TO: Dan Fox, Township Manager
FROM: Scott C. Holbert, Esquire
RE: Amendments to Zoning Ordinance and SALDO
DATE: January 23, 2025

TOWNSHIP OF NEW BRITAIN
BUCKS COUNTY, PENNSYLVANIA

AN ORDINANCE OF THE TOWNSHIP OF NEW BRITAIN, BUCKS COUNTY, PENNSYLVANIA, PROVIDING FOR COMPREHENSIVE AMENDMENTS TO THE NEW BRITAIN TOWNSHIP ZONING ORDINANCE, AS AMENDED, REPEALING INCONSISTENT ORDINANCES OR PARTS OF ORDINANCES; CONTAINING A SAVINGS CLAUSE AND PROVIDING FOR AN EFFECTIVE DATE

Zoning Map New Britain Township

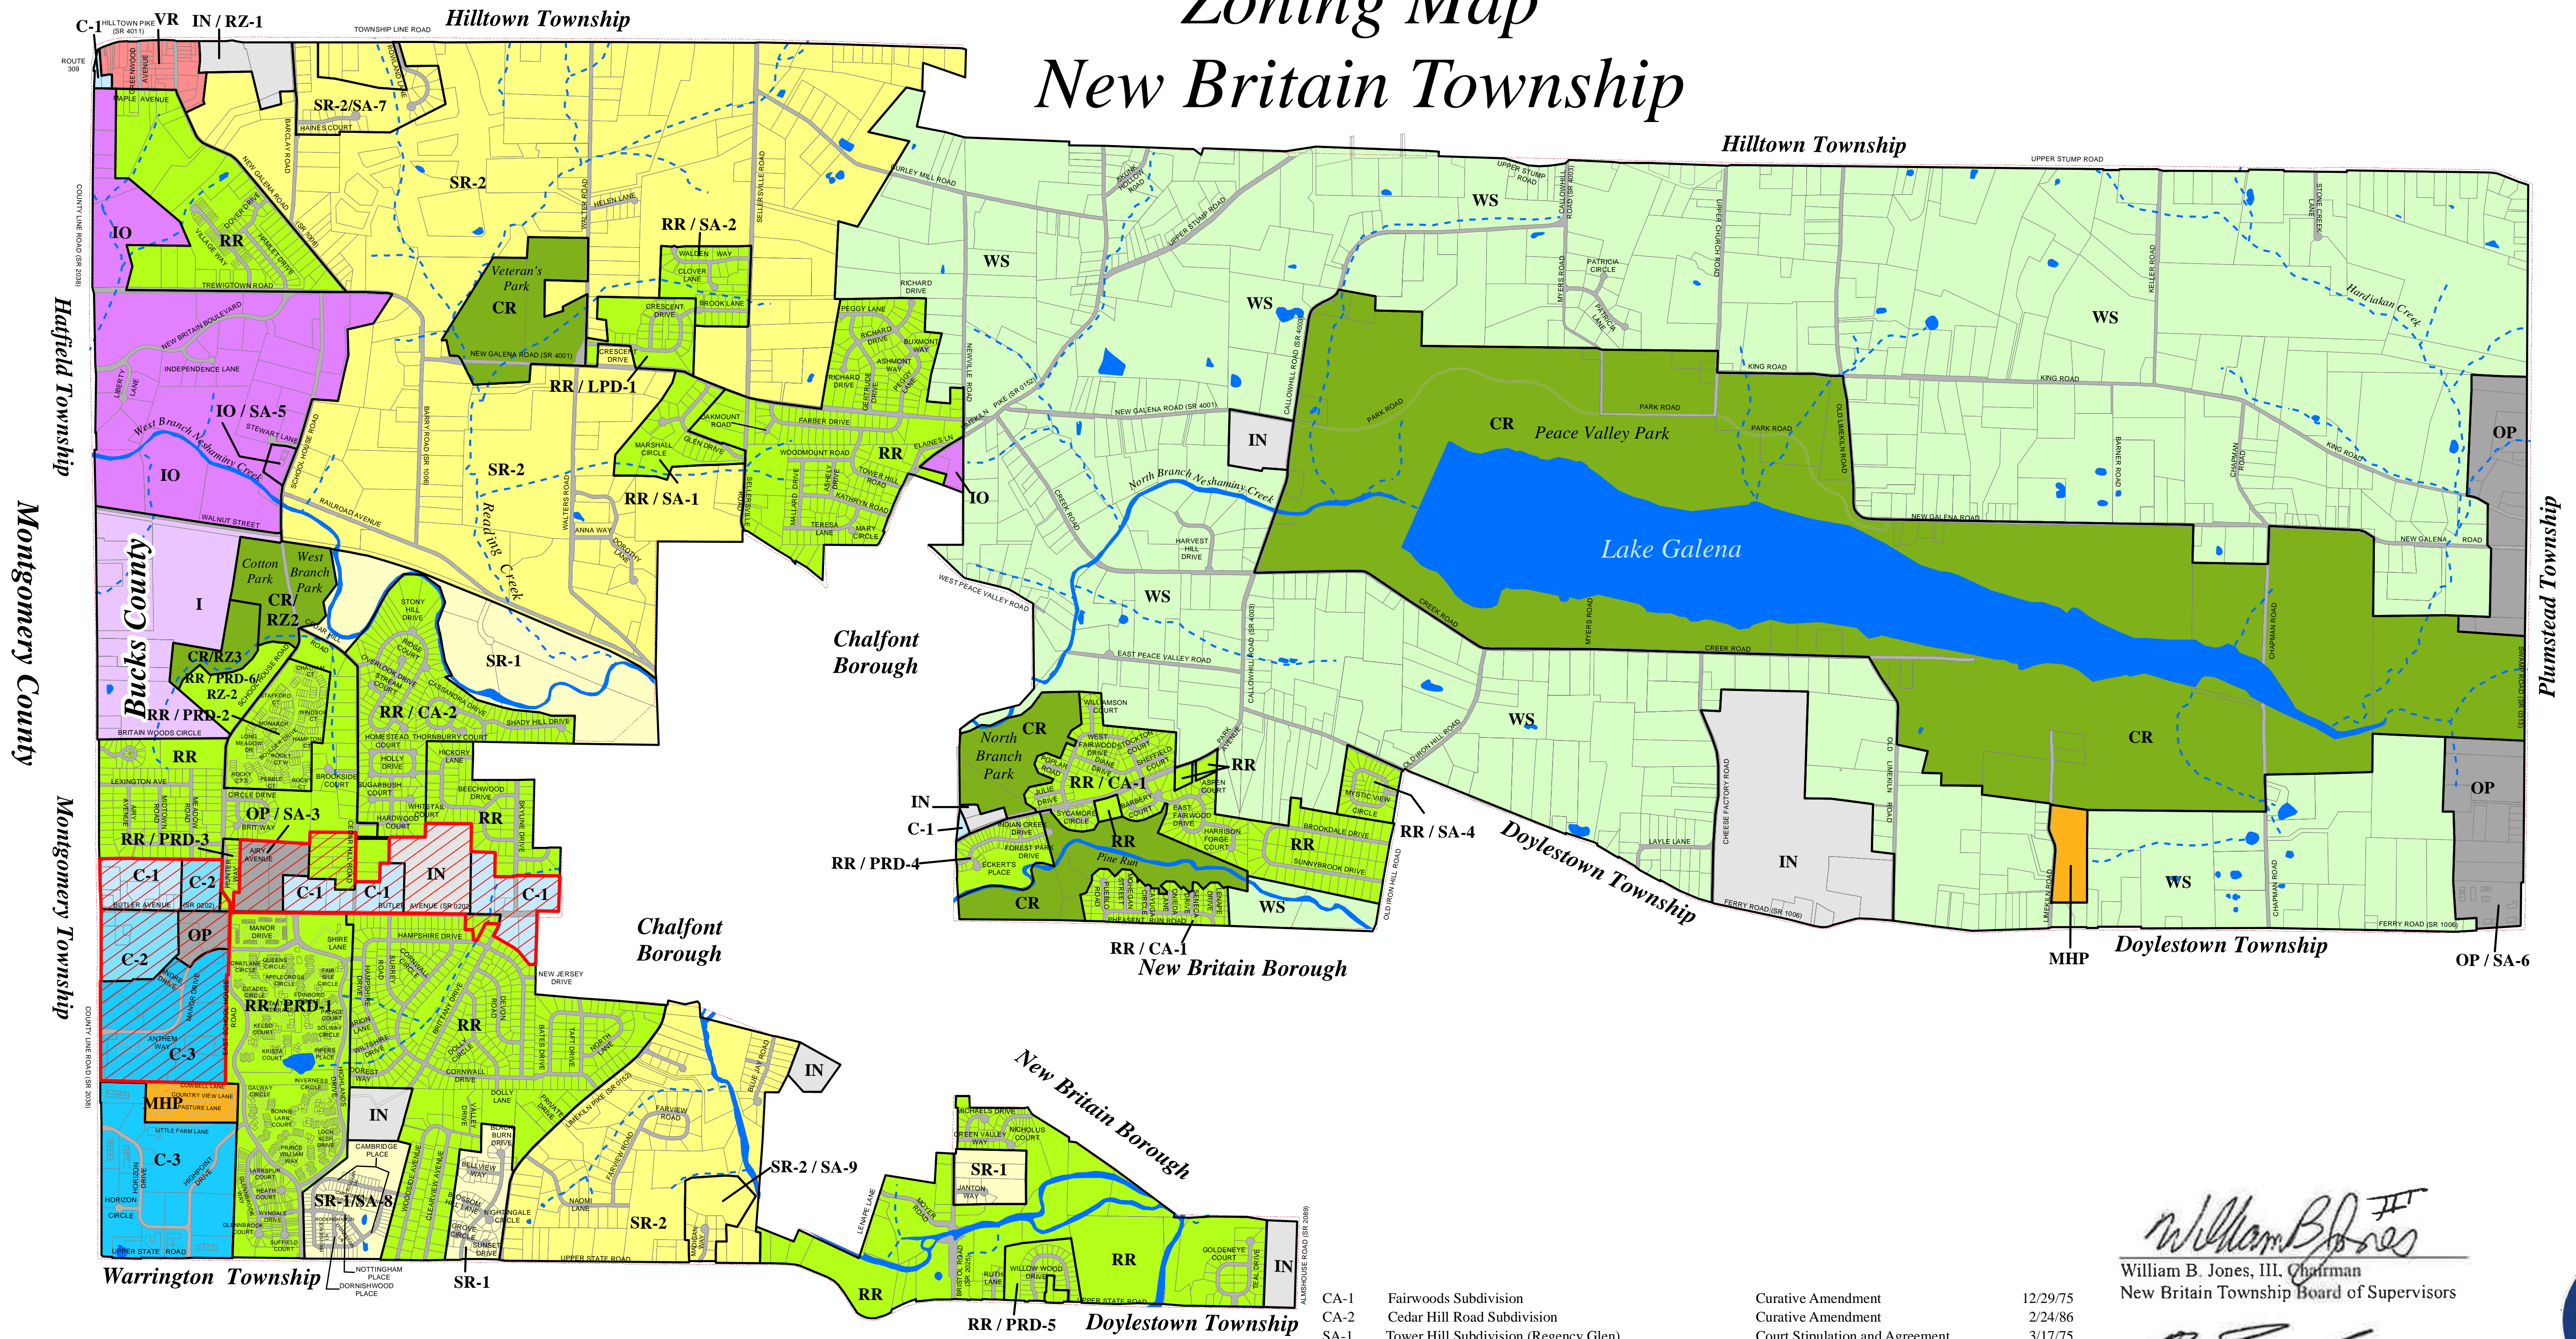
Attachment 3 – Zoning Map – Replace with legible digital copy.

TYPICAL SECTION OF PIER, FENCE, AND HEDGE

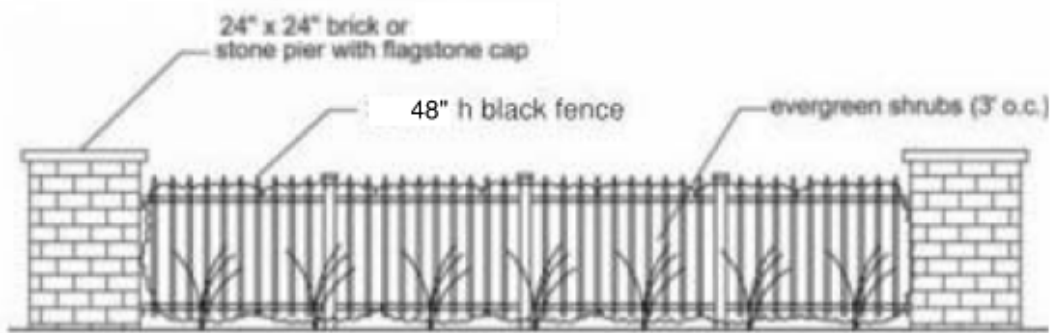
- 1) The fencing shall be black steel or aluminum, [36 inches to 42 48](#) inches in height, and installed and maintained between the masonry piers.

- 2) The masonry piers shall be constructed out of stone or brick, six to 18 inches taller than the fencing between them, 24 ~~to 36~~ inches or greater in width and depth, and with a concrete or stone cap. The piers shall be evenly installed ~~44 to 22~~ 16 to 20 feet on center or at a spacing to be approved by the Township Engineer.
- 3) Evergreen hedge plants, initially at least 18 to 24 inches in height and maintained at a height of no less than 30 inches, shall be installed and maintained between the fencing and the street.
